ARMSTRONG DESIGN ENVELOPE PUMPING UNITS GENERATION 3 (NEMA) | FAQ

File No: 100.220
 Date: AUGUST 03, 2015
 Supersedes: NEW
 Date: NEW

Series 4300
 Design Envelope: 0308-025.0
 Integrated intelligent variable speed with Sensorless control

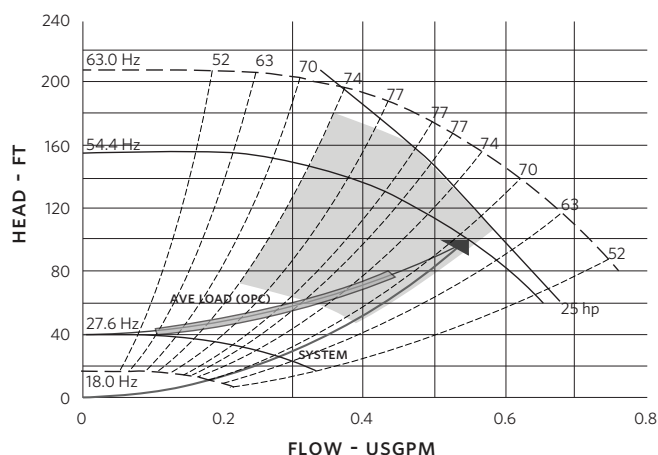
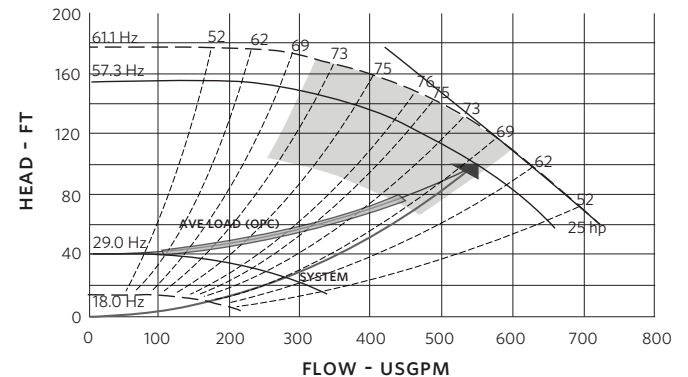
A number of changes have been made to selection envelopes. Firstly, impeller trim diameters and operating speeds have changed with the most notable difference being that 50Hz nominal speeds are now no longer in the range with better 60Hz nominal speeds being selected. The second noticeable change is that the yellow selection envelope has changed as can be seen in the following AOL output:

Key differences are the flow at which max motor power is reached is now model dependant and the bottom of the selection envelope has changed to prevent selections being made that are too low in the operating range which could result in minimum speed being reached before the minimum head on the control curve. The yellow selection envelope does not represent the operating limits of the pump, merely the optimised selection envelope.
